Our Ref: R/2019/2/I  
File No: 2021/479227  
Your Ref: SSD-9429-Mod-6  
SSD-9835-Mod-7

**Sydney Football Stadium - New Precinct Village and Carpark  
Stage 1 - SSD-9429 - Modification 6; and  
Stage 2 - SSD 9835 - Modification 7**

**Figure 2**

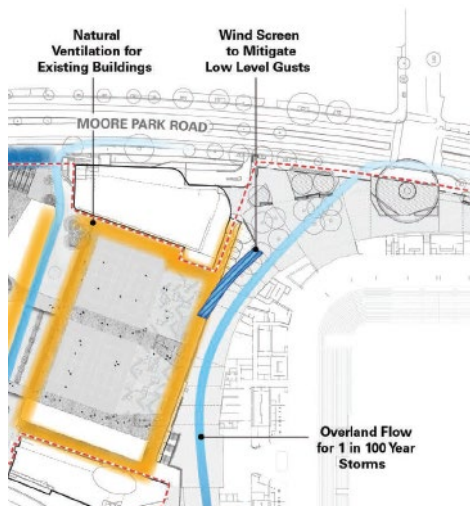
The Eastern edge of the Rugby Australia building shows a wind screen to mitigate wind gusts (see Figure 2 below). The location will impact on new trees previously approved in SSD 9835 (See Figure 3).

Clarification is requested as to whether a wind study has been prepared and the rationale behind providing this screen. It is requested that the applicant submit design details to confirm impacts and wind screen design.
